# AGENDA

**The Columbia Architectural Design Review Team will meet on Tuesday, June 7th, 2022 at 8:00 a.m. in Conference Room A on the basement level of City Hall, 700 N. Garden Street to consider the following:**

ELEVATIONS

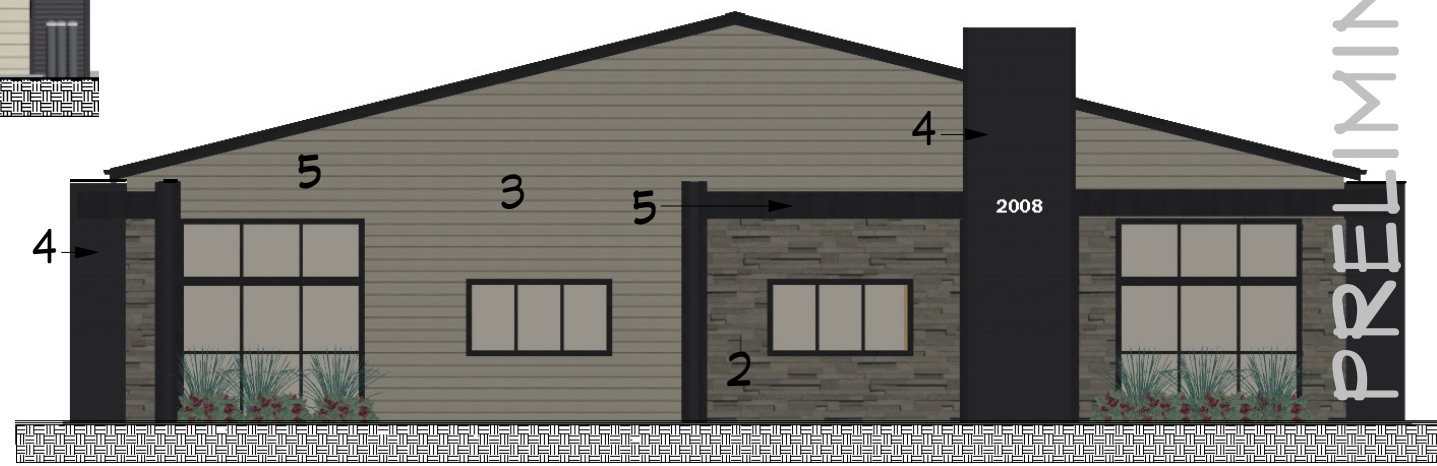
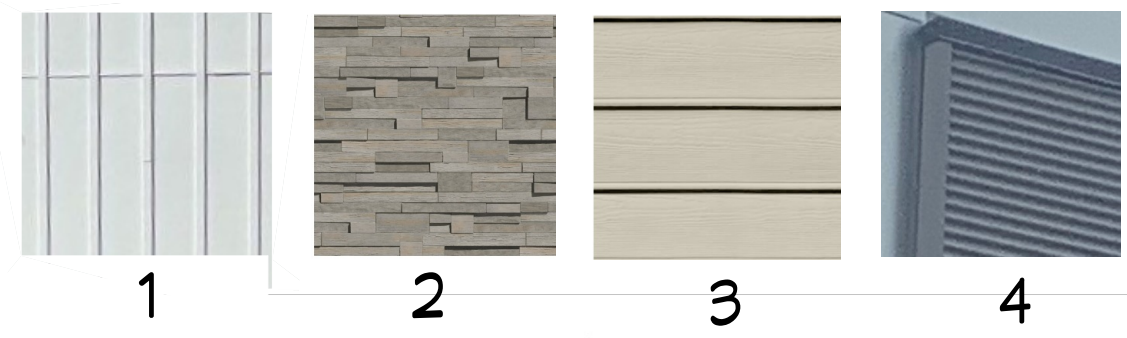
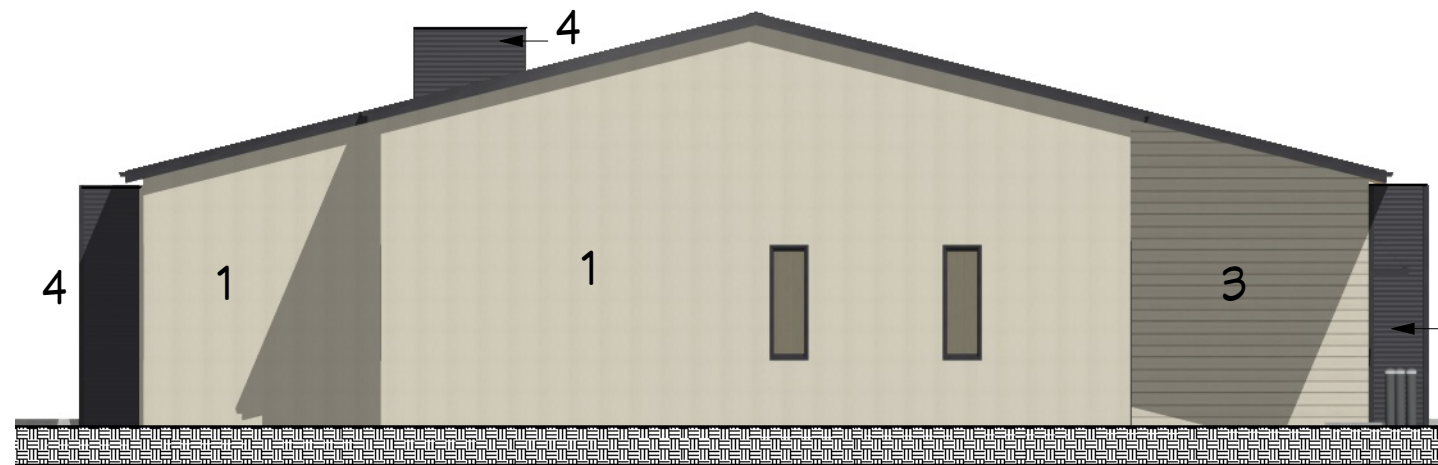
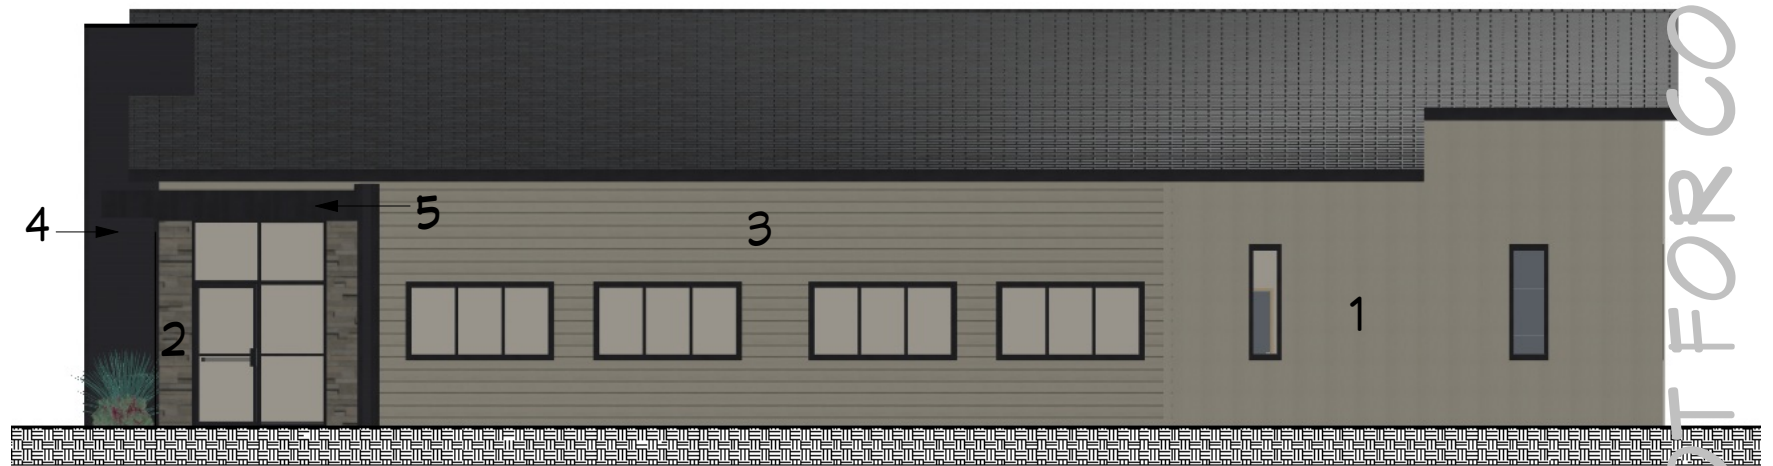
This request is for the façade modification of an existing pre-fabricated metal building. The modification consists of recladding of a corrugated metal façade with fiber cement board and additional window openings including a front tower addition.

- The front facade consists of the recladding of metal with fiber cement board and the material change from brick to a ledge stone. Alternative compliance has been requested to allow for corrugated metal accents to the front façade. These materials meet the design standards as referenced with the exception of corrugated metal.

- A left and right elevation indicate the primary facade materials of a fiber cement board and batten including fiber cement board lap siding. In addition, a metal clad awning has been added over door openings. These materials meet the design standards as referenced.

- The rear elevation consists of the primary façade materials of board and batten lap siding including horizontal siding material consisting of fiber cement board. These materials meet the design standards as referenced.

- Alternative compliance has been requested to allow for minor sections of corrugated metal to be integrated in the faced change located at a proposed tower and end cap of the elevations.

**1 WEST ELEVATION**

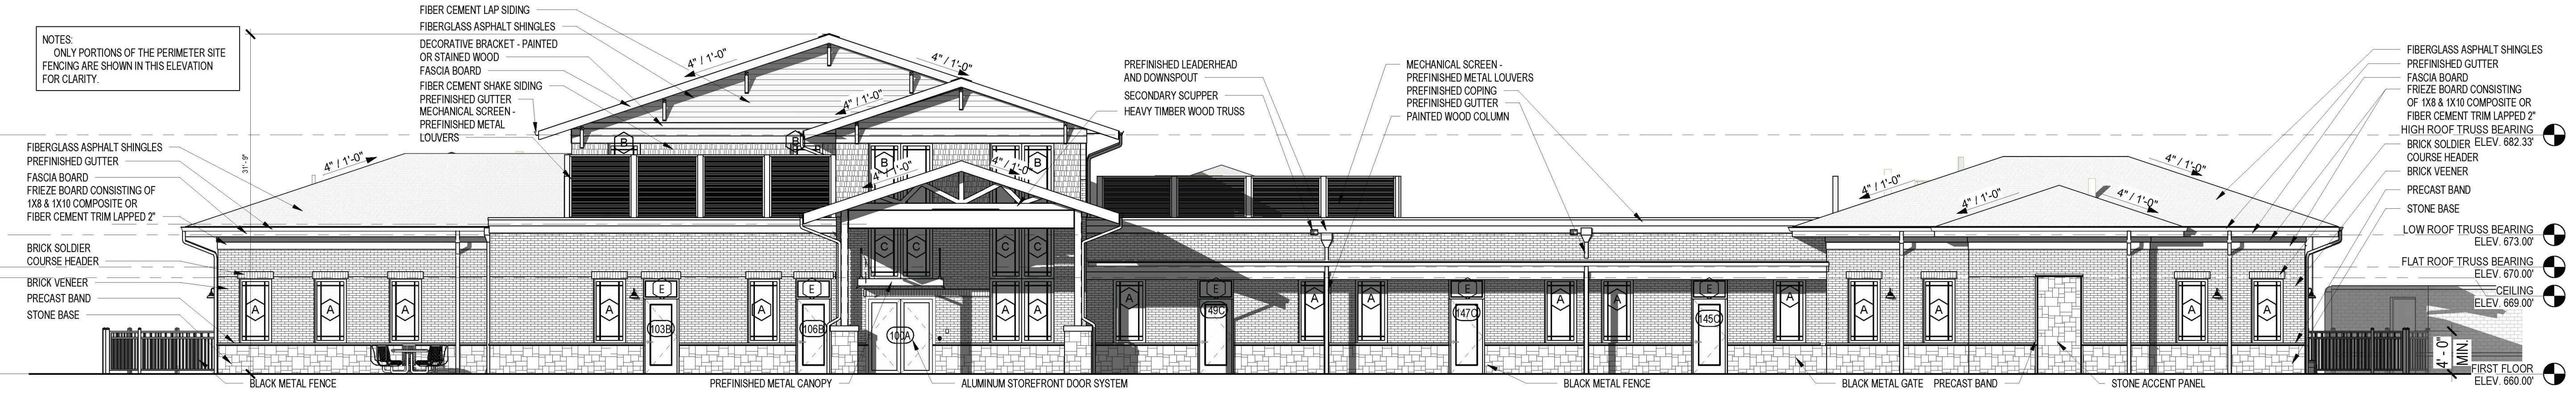
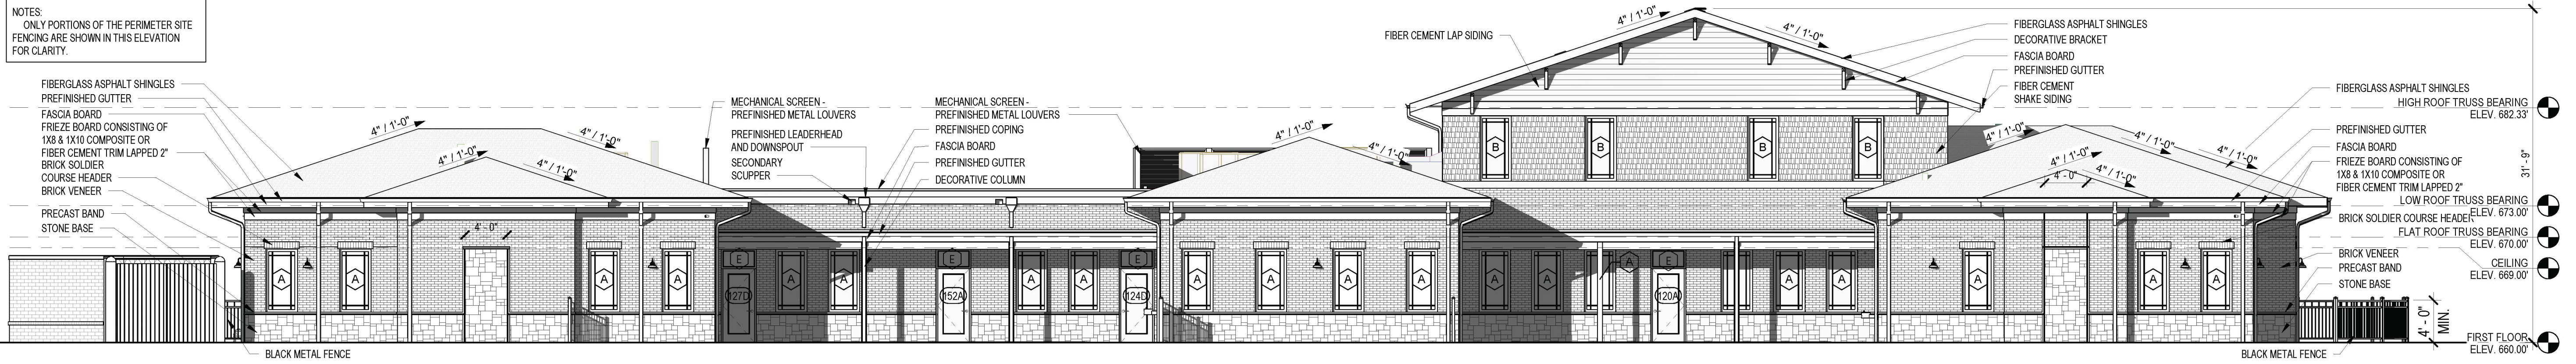
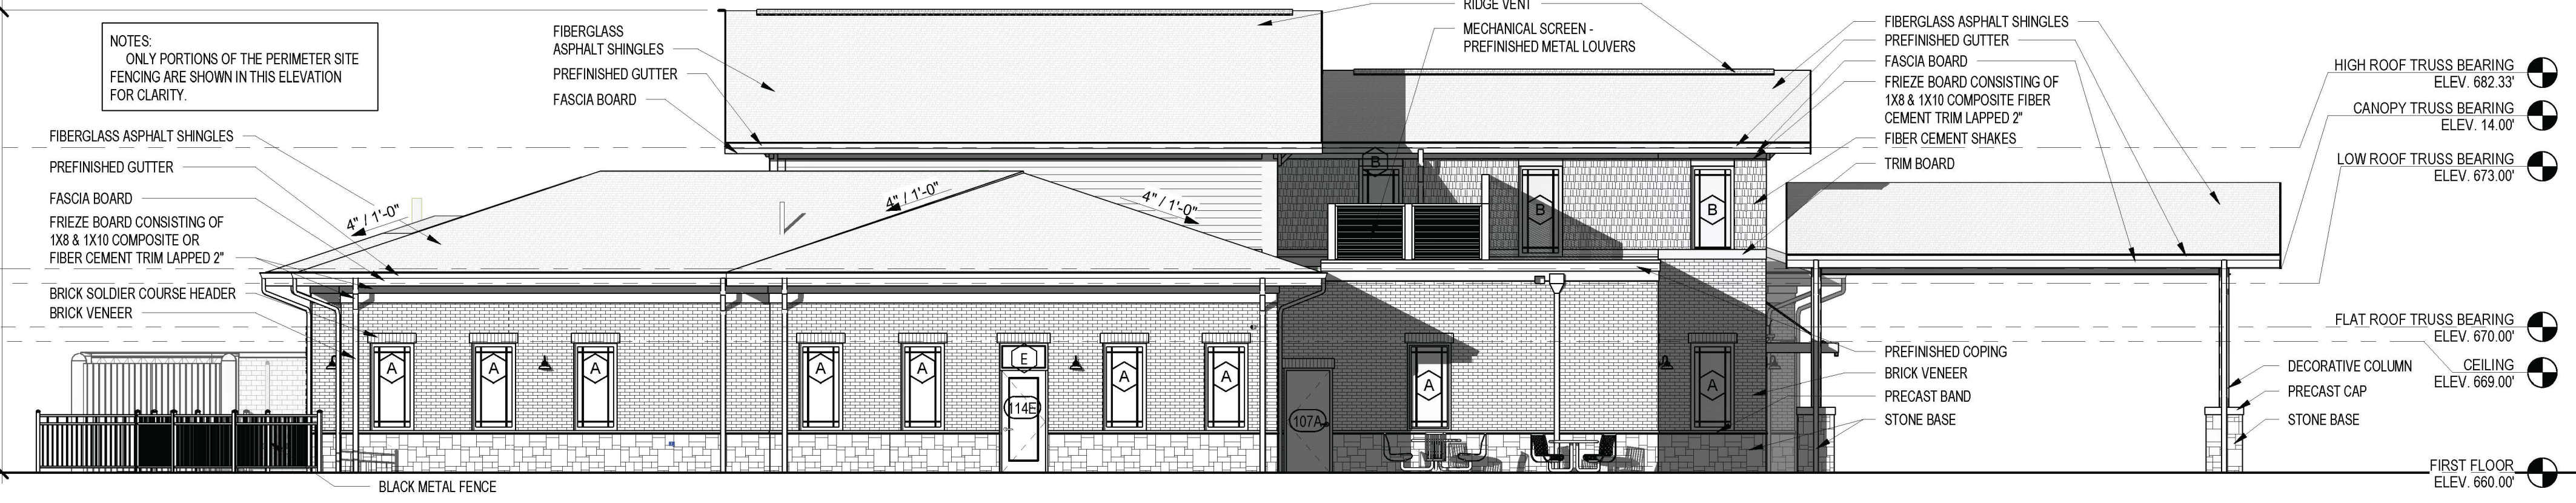
- The front facade (west elevation) consists of a primary material of brick accented by a stone base and fiber cement board clad gables. These materials meet the design standards as referenced with no unbroken façade plane less than 35’.
- The east elevation consists of a primary material of brick accented by a stone base. These materials meet the design standards as referenced with no unbroken façade plane less than 35’
- The south and north elevation consist of a primary façade material of brick accented by a stone base. These materials meet the design standards as referenced with no unbroken façade plane less than 35’. As noted, the mechanical units on the north elevation is proposed to be screened by prefinished metal louvers.
